**DEPARTMENT OF TRANSPORTATION
STATE OF GEORGIA**

SUBJECT **APPROVED CONCEPT REPORT**

**DEPARTMENT OF TRANSPORTATION
STATE OF GEORGIA
LIMITED SCOPE PROJECT CONCEPT REPORT**

Review of Concept Layouts:

PI 0011672
CONCEPT LAYOUT
OCTOBER 2013
INT #5 SR 11 @ SR 11 CONN.

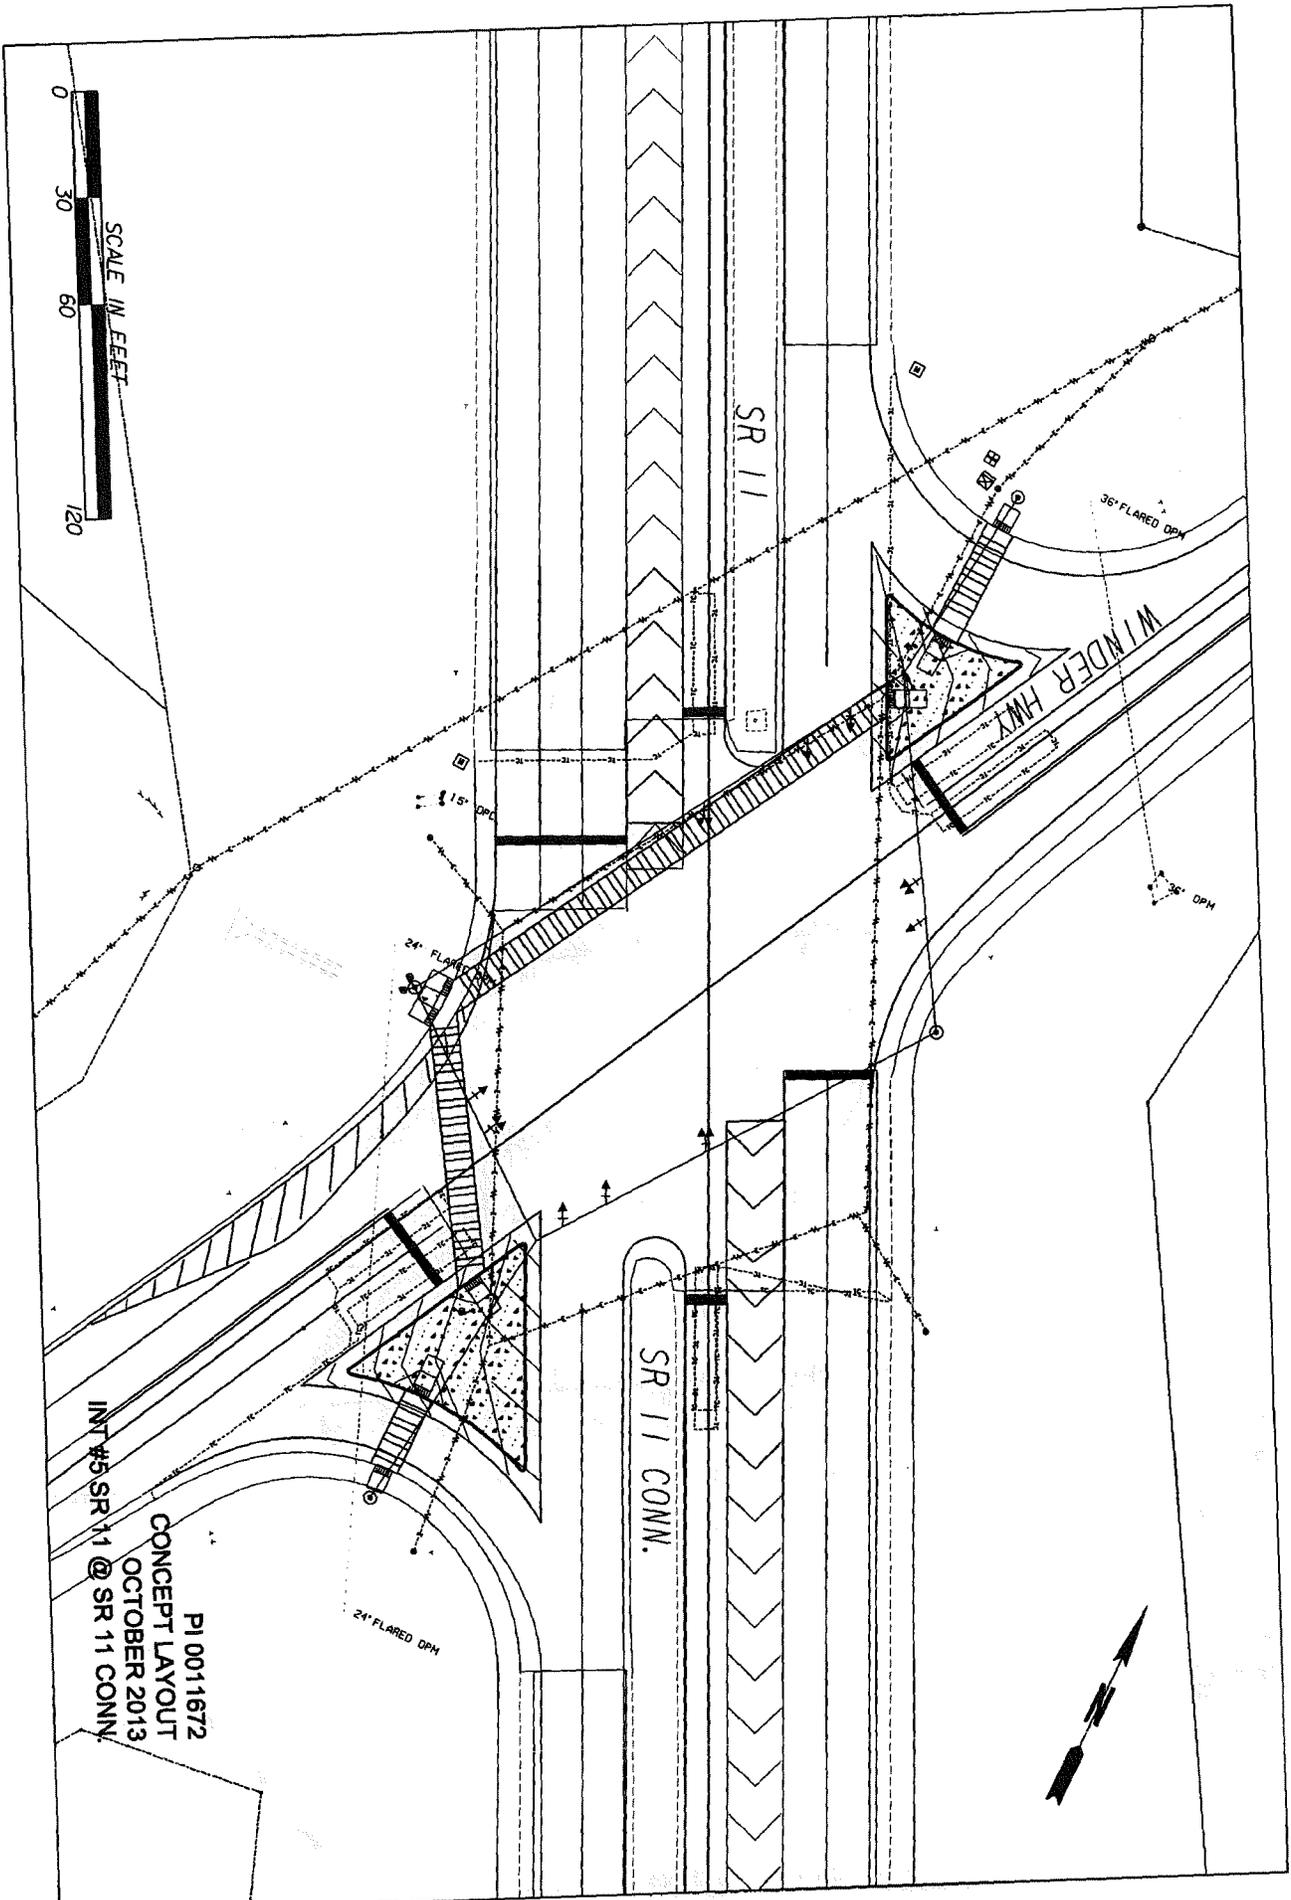
Intersection #5

- Include a crosswalk on the north side of SR 11, roughly following the existing span wire
- The concrete pad on the east corner will not fit with the guardrail, the crossing to this corner can be removed.
- This intersection will need to be converted to span wire

PI 0011672
CONCEPT LAYOUT
OCTOBER 2013
INT #6 SR 11 @ I-85 NB

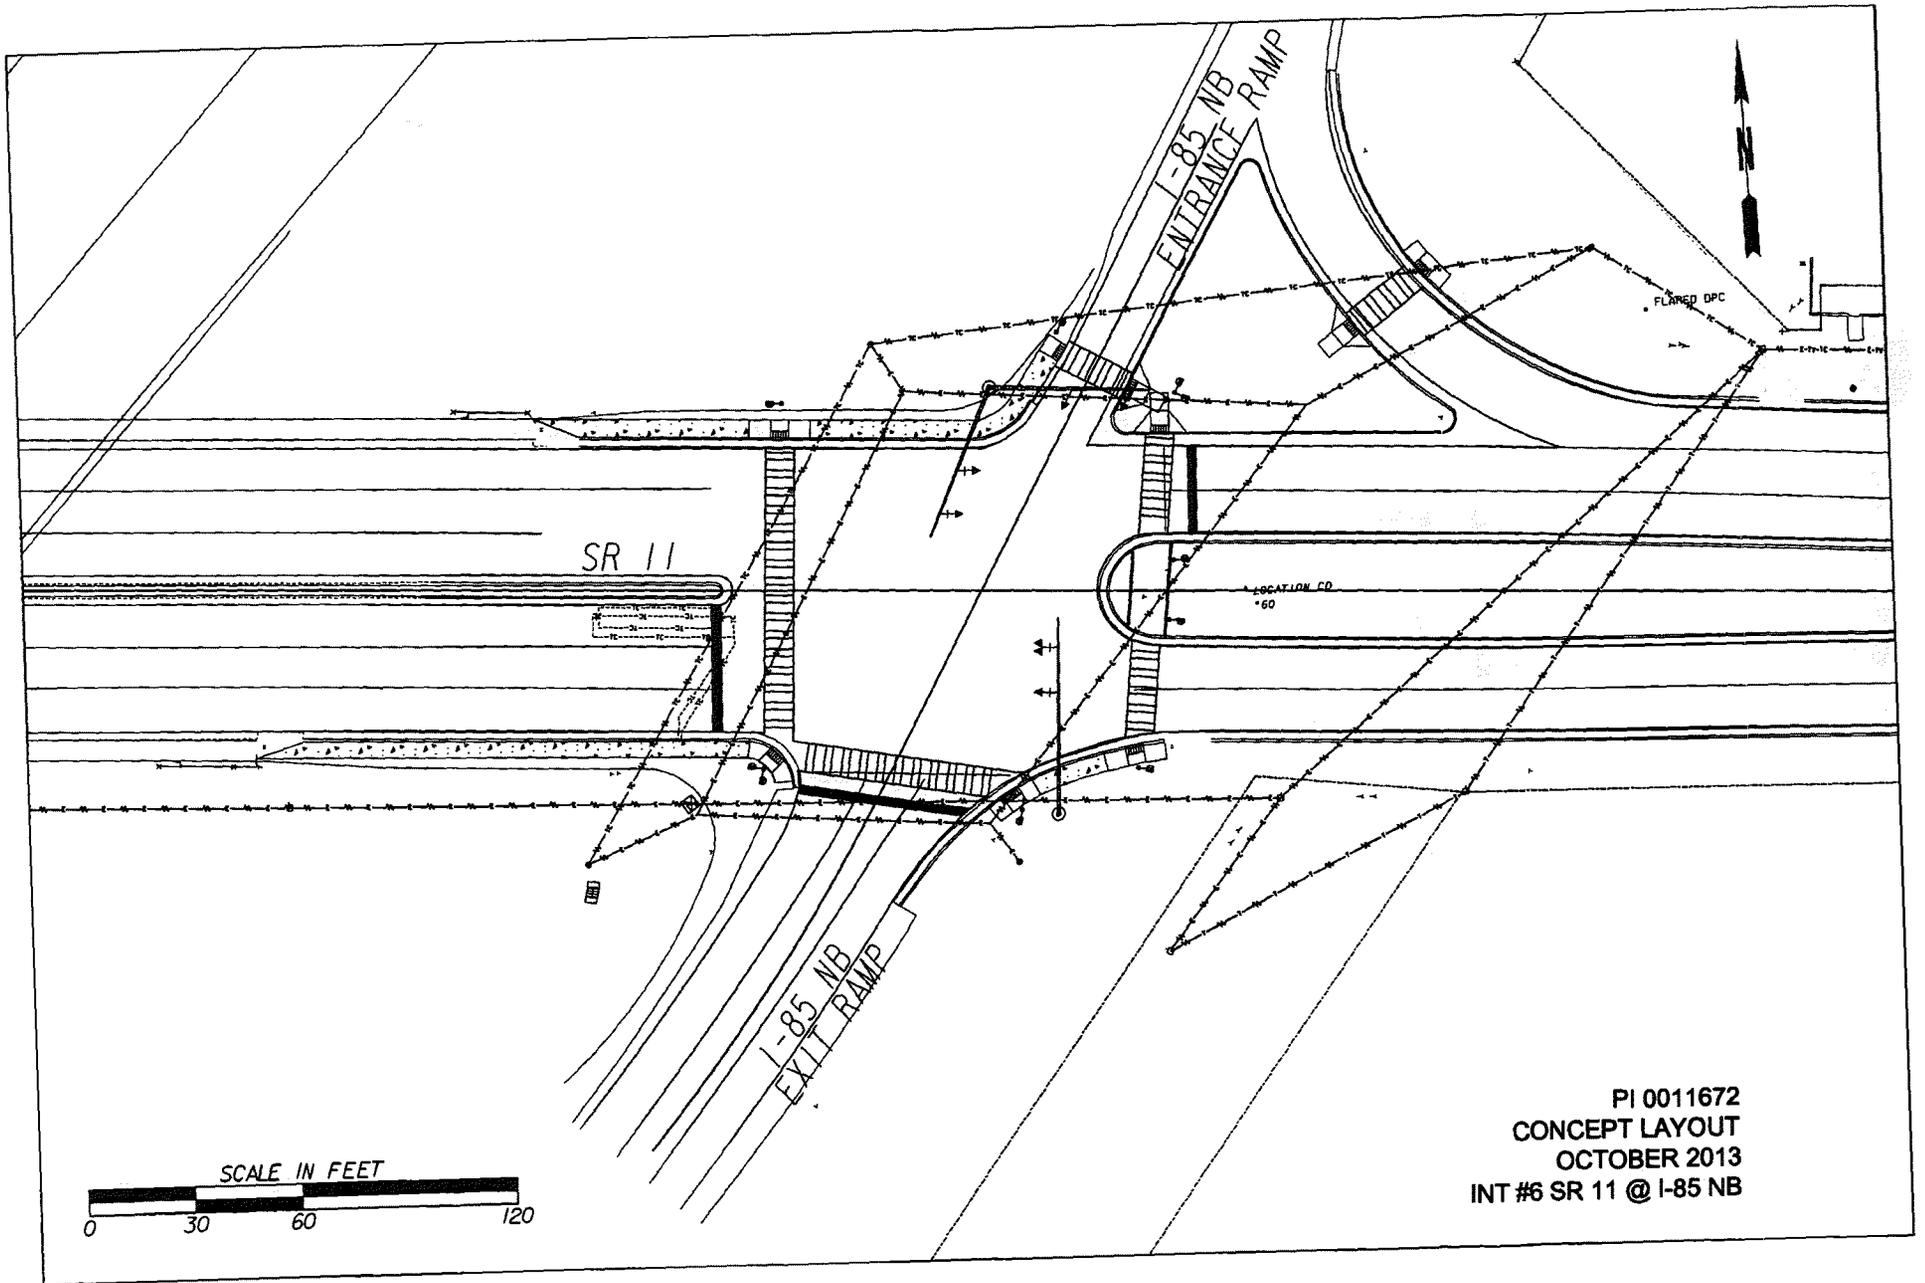
Intersection #6

- Extend the sidewalk to the bridge on both sides of SR 11
- Remove the mast arm from the NE island and combine this mast arm with onto the strain pole in the NW corner, adjust the location of the strain pole as necessary. Add ped poles as necessary
- Adjust the crosswalk across the western approach to be perpendicular to the roadway.

PI 0011672
CONCEPT LAYOUT
OCTOBER 2013
INT #7 SR 11 @ I-85 SB

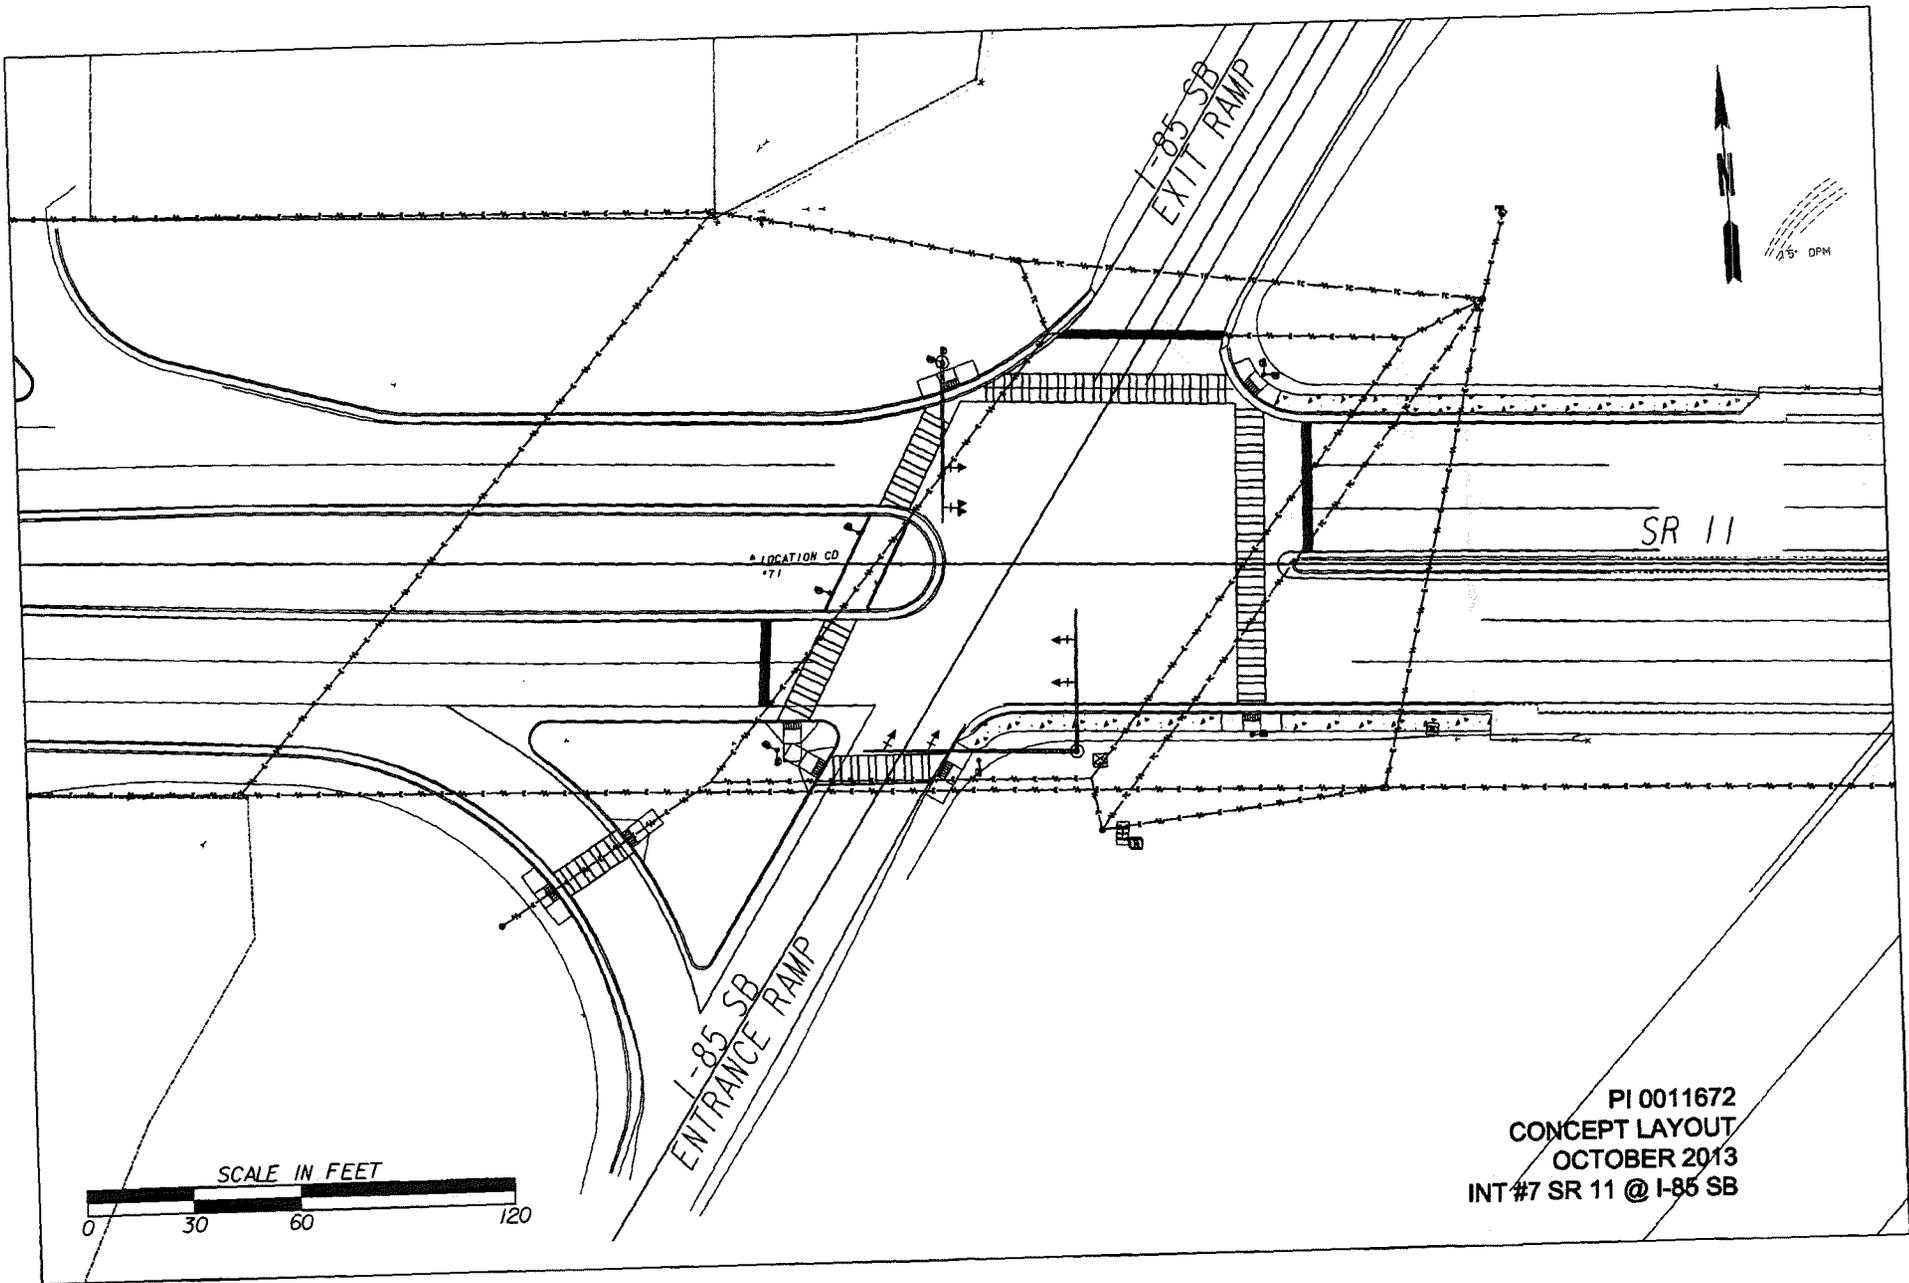
Intersection #7

- Extend the sidewalk to the bridge on both sides of SR 11
- A ped pole may be required in the median on the north side, check requirements

INT #8 SR 11 CONN. @ SR 15 ALT.

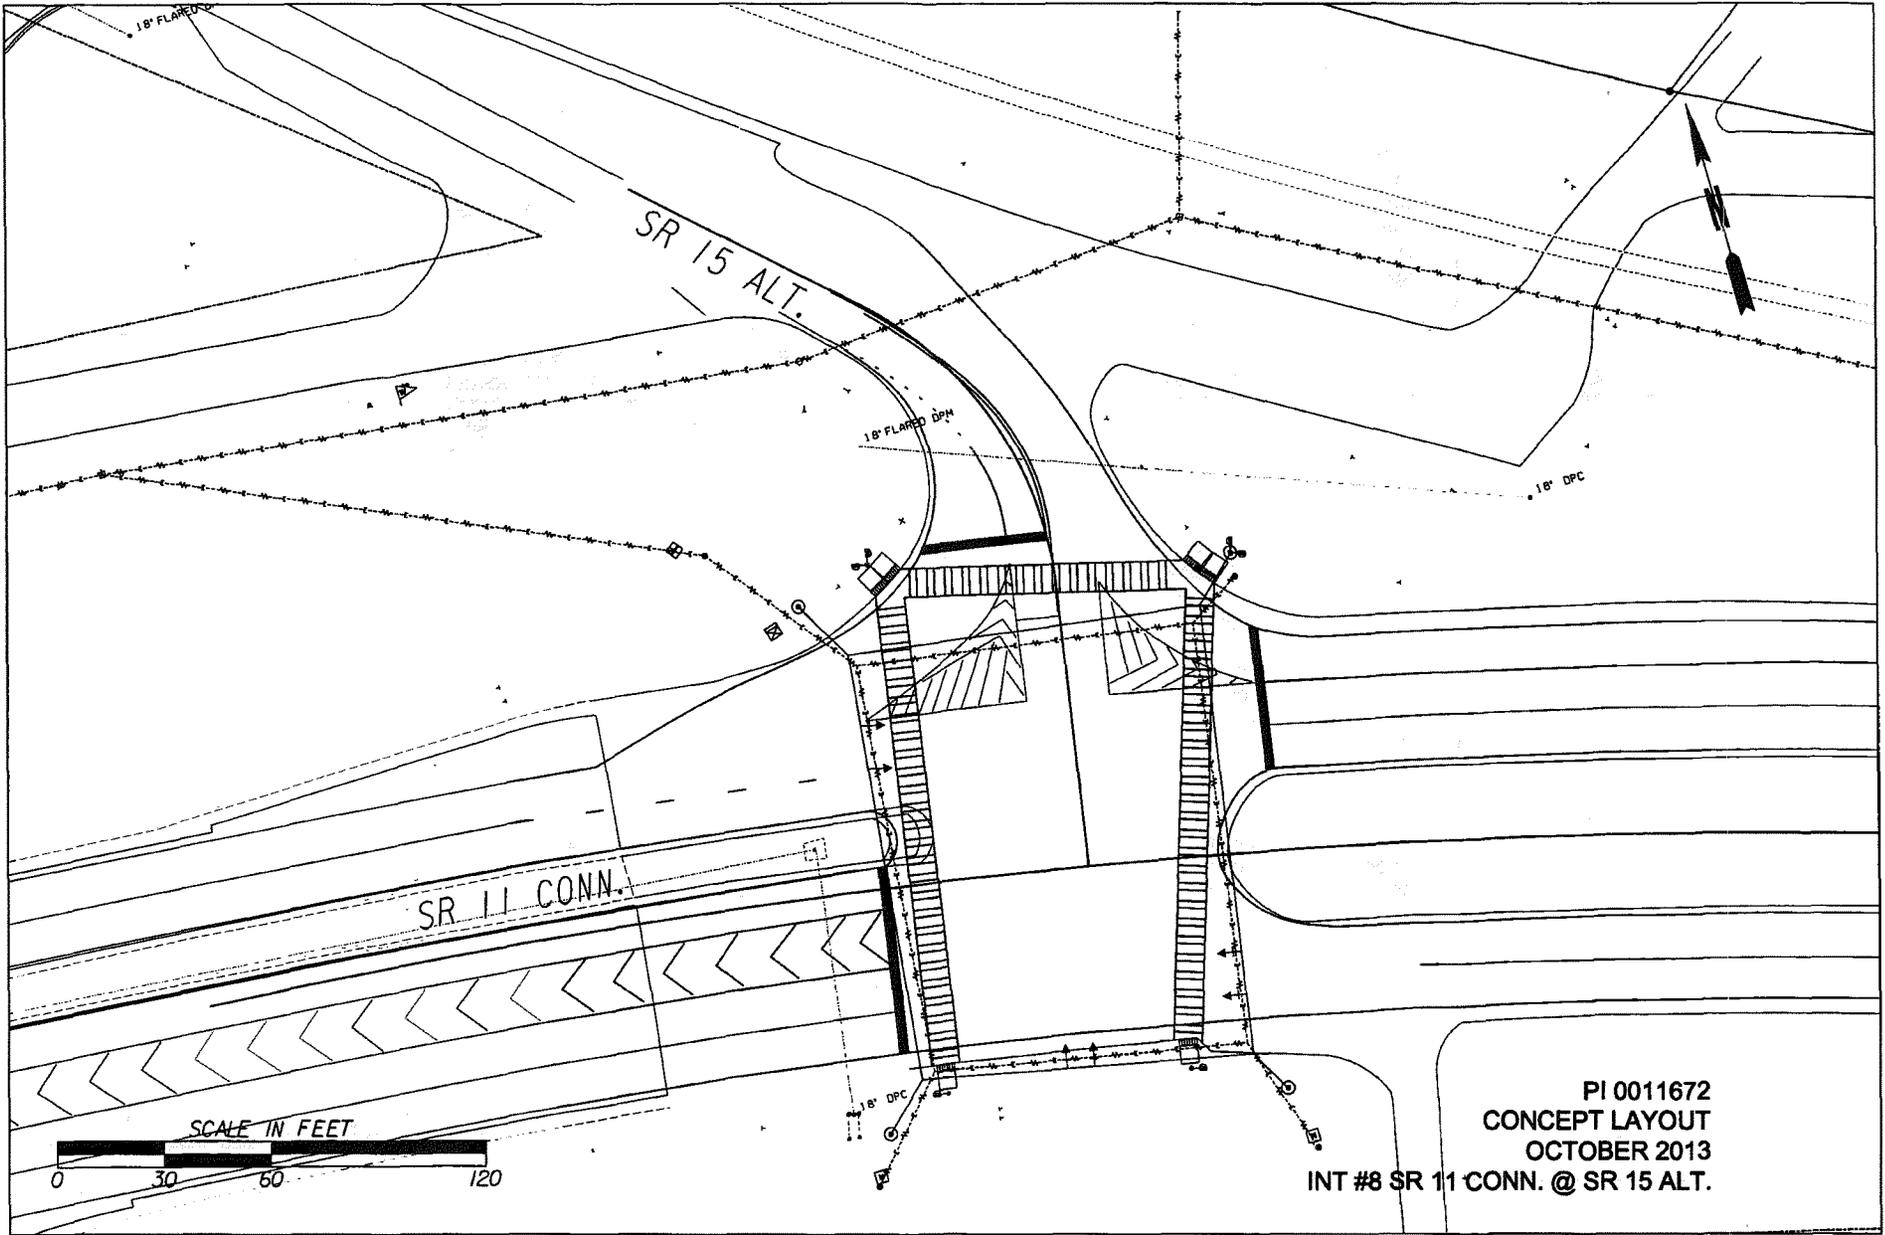
Intersection #8

- Include a crosswalk across SR 15 Alt

- A supplemental head will be required for SR 15 Alt
- Check the turning movement from SR 15 Alt to SR 11 Conn and adjust median as necessary
- This will need to be converted to a span wire configuration to allow for future left turn signal heads.
